HISTORIC AND DESIGN REVIEW COMMISSION

February 07, 2018

HDRC CASE NO: 2018-043
ADDRESS: 722 MASON ST
LEGAL DESCRIPTION: NCB 1276 BLK 8 LOT 6
ZONING: R-5, H
CITY COUNCIL DIST.: 2
DISTRICT: Government Hill Historic District
APPLICANT: Jesse Amado
OWNER: Jesse Amado
TYPE OF WORK: Install window in existing dormer
APPLICATION RECEIVED: January 18, 2018
60-DAY REVIEW: March 17, 2018

The applicant is requesting a Certificate of Appropriateness for approval to: install window into existing window opening in second floor dormer.

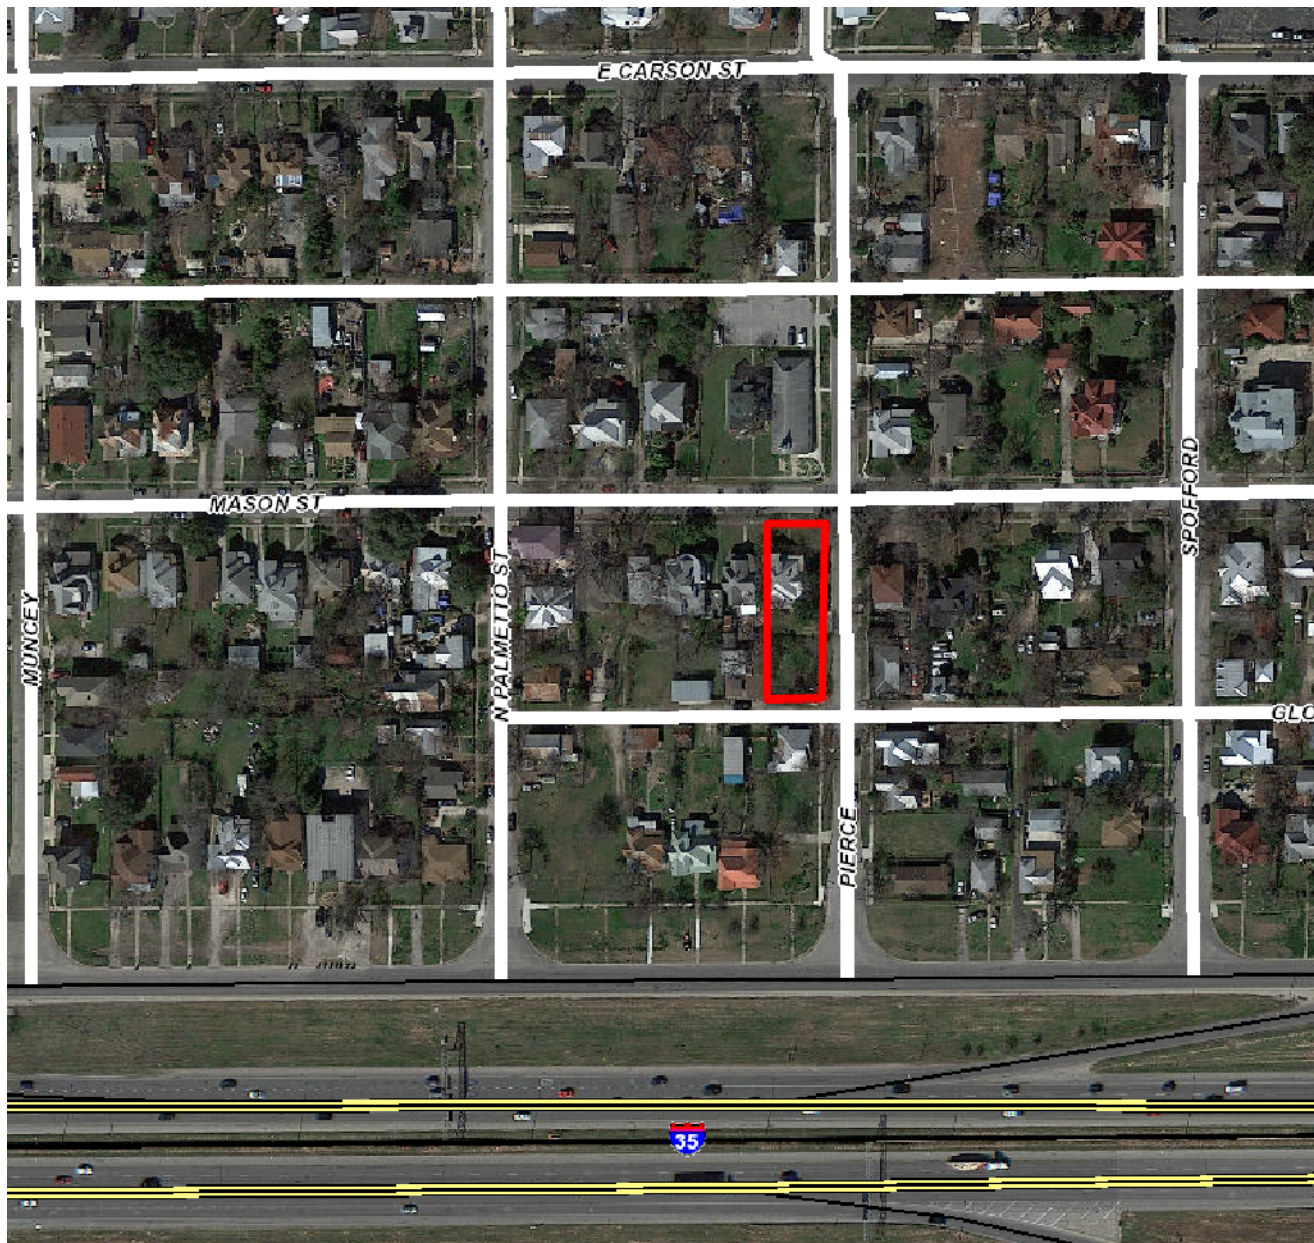
- b. **DORMER** – The applicant has installed a single-light fixed window into the dormer prior to approval. Photographs show that the window opening had been boarded with plywood since at least 2008. The Guidelines for Windows 6.B.vii notes that non-historic incompatible windows should be replaced with windows that are typical of the architectural style of the building. Given that there is evidence that a window was not installed in the dormer for a number of years, staff finds that the installed fixed window is an improvement upon the previous plywood boarding. Staff also finds that a wood window screen comparable to the configuration of a double-hung window would be an appropriate to restore the character of the historic dormer.

Staff recommends the approval to install a fixed window into the dormer window opening based on finding b with the stipulation that a wood window screen of a traditional configuration also be installed to minimize the visual impact of the new window.
